Product Change Notice (PCN)

PCN Number: PCN-0451520R-01

Product(s) Affected: PJ-030DH-SMT-TR

PREVIOUS CUI DEVICES DETAIL / IMAGE	NEW CUI DEVICES DETAIL / IMAGE
<p>Recommended PCB Layout Top View</p>	<p>Recommended PCB Layout Top View</p>

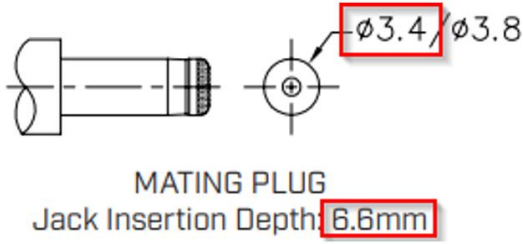
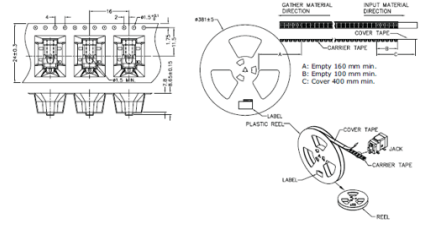
Description of Change: mechanical, material, packaging, and soldering differences as shown below:

<table border="1"> <thead> <tr> <th></th> <th>MATERIAL</th> <th>PLATING</th> </tr> </thead> <tbody> <tr> <td>center pin</td> <td>copper</td> <td>nickel</td> </tr> <tr> <td>terminal 1</td> <td>brass</td> <td>silver</td> </tr> <tr> <td>terminal 2</td> <td>copper alloy</td> <td>silver</td> </tr> <tr> <td>terminal 3</td> <td>brass</td> <td>silver</td> </tr> <tr> <td>shield</td> <td>cold rolled steel</td> <td>nickel</td> </tr> <tr> <td>plastic</td> <td>PA6T or equivalent</td> <td></td> </tr> </tbody> </table>		MATERIAL	PLATING	center pin	copper	nickel	terminal 1	brass	silver	terminal 2	copper alloy	silver	terminal 3	brass	silver	shield	cold rolled steel	nickel	plastic	PA6T or equivalent		<table border="1"> <thead> <tr> <th>DESCRIPTION</th> <th>MATERIAL</th> <th>PLATING/COLOR</th> </tr> </thead> <tbody> <tr> <td>center pin</td> <td>brass</td> <td>tin</td> </tr> <tr> <td>terminal 1</td> <td>brass t=0.3</td> <td>silver</td> </tr> <tr> <td>terminal 2</td> <td>phosphorus bronze t=0.3</td> <td>silver</td> </tr> <tr> <td>terminal 3</td> <td>brass t=0.4</td> <td>silver</td> </tr> <tr> <td>shield</td> <td>stainless steel</td> <td>nickel</td> </tr> <tr> <td>housing</td> <td>PPA (UL94V-0)</td> <td>black</td> </tr> </tbody> </table>	DESCRIPTION	MATERIAL	PLATING/COLOR	center pin	brass	tin	terminal 1	brass t=0.3	silver	terminal 2	phosphorus bronze t=0.3	silver	terminal 3	brass t=0.4	silver	shield	stainless steel	nickel	housing	PPA (UL94V-0)	black

MATERIAL	PLATING																																															
center pin	copper	nickel																																															
terminal 1	brass	silver																																															
terminal 2	copper alloy	silver																																															
terminal 3	brass	silver																																															
shield	cold rolled steel	nickel																																															
plastic	PA6T or equivalent																																																
DESCRIPTION	MATERIAL	PLATING/COLOR																																															
center pin	brass	tin																																															
terminal 1	brass t=0.3	silver																																															
terminal 2	phosphorus bronze t=0.3	silver																																															
terminal 3	brass t=0.4	silver																																															
shield	stainless steel	nickel

housing	PPA (UL94V-0)	black																																															
 <p>MATING PLUG Jack Insertion Depth: 6.6mm</p>	 <p>MATING PLUG Jack Insertion Depth: 6.5mm</p>																																																
<p>SOLDERABILITY</p> <table border="1"> <thead> <tr> <th>parameter</th> <th>conditions/description</th> <th>min</th> <th>typ</th> <th>max</th> <th>units</th> </tr> </thead> <tbody> <tr> <td>reel storage</td> <td>at relative humidity <80%</td> <td></td> <td></td> <td>40</td> <td>°C</td> </tr> <tr> <td>reflow soldering¹</td> <td>see reflow profile</td> <td>255</td> <td>260</td> <td>265</td> <td>°C</td> </tr> <tr> <td>drying conditions²</td> <td>parts in reel: bake at 40°C ±5°C for 72 hours parts removed from reel: bake at 40°C ±5°C for 10 hours</td> <td></td> <td></td> <td></td> <td></td> </tr> </tbody> </table> <p>Note: 1. Must reflow solder within 72 hours from opening vacuum packaging at a temperature <±30°C & relative humidity <60%. 2. When exceeding floor life by >72 hours.</p> 	parameter	conditions/description	min	typ	max	units	reel storage	at relative humidity <80%			40	°C	reflow soldering ¹	see reflow profile	255	260	265	°C	drying conditions ²	parts in reel: bake at 40°C ±5°C for 72 hours parts removed from reel: bake at 40°C ±5°C for 10 hours					<p>SOLDERABILITY</p> <table border="1"> <thead> <tr> <th>parameter</th> <th>conditions/description</th> <th>min</th> <th>typ</th> <th>max</th> <th>units</th> </tr> </thead> <tbody> <tr> <td>reel storage</td> <td>10-30°C, <70% humidity</td> <td></td> <td></td> <td></td> <td>°C</td> </tr> <tr> <td>reflow soldering¹</td> <td>see reflow profile</td> <td>255</td> <td>260</td> <td></td> <td>°C</td> </tr> <tr> <td>drying conditions²</td> <td>parts in reel: bake at 110°C for 4 hours parts removed from reel: bake at 110°C for 4 hours</td> <td></td> <td></td> <td></td> <td></td> </tr> </tbody> </table> <p>Note: 1. CUDEVICES recommends to solder within 72 hours from opening vacuum packaging at a temperature <±30°C & relative humidity <60%. 2. When exceeding floor life by >48 hours.</p> 	parameter	conditions/description	min	typ	max	units	reel storage	10-30°C, <70% humidity				°C	reflow soldering ¹	see reflow profile	255	260		°C	drying conditions ²	parts in reel: bake at 110°C for 4 hours parts removed from reel: bake at 110°C for 4 hours

parameter	conditions/description	min	typ	max	units																																												
reel storage	at relative humidity <80%			40	°C																																												
reflow soldering ¹	see reflow profile	255	260	265	°C																																												
drying conditions ²	parts in reel: bake at 40°C ±5°C for 72 hours parts removed from reel: bake at 40°C ±5°C for 10 hours																																																
parameter	conditions/description	min	typ	max	units																																												
reel storage	10-30°C, <70% humidity				°C																																												
reflow soldering ¹	see reflow profile	255	260		°C																																												
drying conditions ²	parts in reel: bake at 110°C for 4 hours parts removed from reel: bake at 110°C for 4 hours																																																
<p>Reel Size: 0321 mm Reel QTY: 600 pcs per reel</p>  <p> OTHER MATERIAL DIRECTION SPLIT MATERIAL DIRECTION COVER TAPE JACK CARRIER TAPE LABEL PLASTIC REEL REEL </p> <p> A: Empty 16.0 mm min. B: Empty 10.0 mm min. C: Cover 4.0 mm min. </p>	 <p> OTHER MATERIAL DIRECTION SPLIT MATERIAL DIRECTION COVER TAPE JACK CARRIER TAPE LABEL PLASTIC REEL REEL </p>
